**MODIFICATION REQUEST:
Children's Medical Research Institute
(MP08_0159 MOD 1)**

Director-General's
Environmental Assessment Report
Section 75W of the
Environmental Planning and Assessment Act 1979

October 2011

Figure 4: Hawkesbury Road elevation of the CMRI building (as proposed)

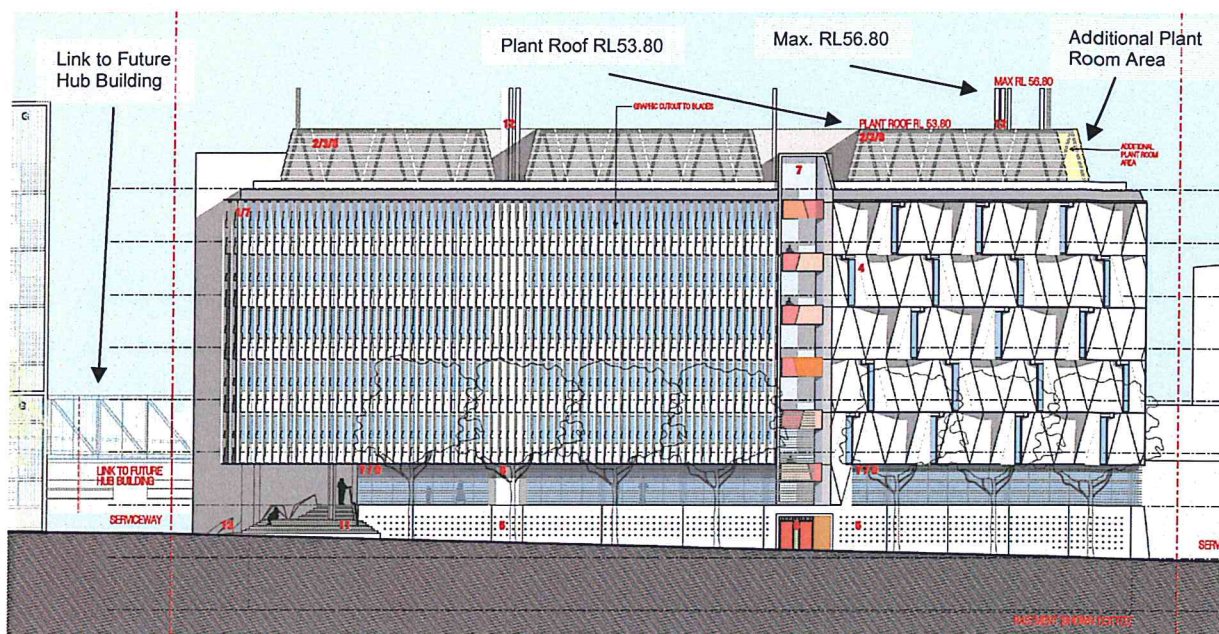
The height of the CMRI building will increase by approximately 3.9 m, from 27.9 m to 31.8 m (RL 53.8) to the top of the roof plant, as a consequence of the proposed modifications. Also, the GFA of the development will increase by 3,290 sqm (total 22,550 sqm), resulting in an increase in FSR from 4.04:1 to 4.72:1.

As can be seen in Figure 5, the height of the approved CMRI building is significantly lower than the WMI building, and as a consequence of the proposed modifications the CMRI will still be 2.2 m lower than the adjoining WMI building at the plant roof level (see Figure 4).

In this respect, the department considers the proposed height of the modified CMRI building to be acceptable within the context of existing surrounding development and consistent with the vision of future medical & health related and residential development.
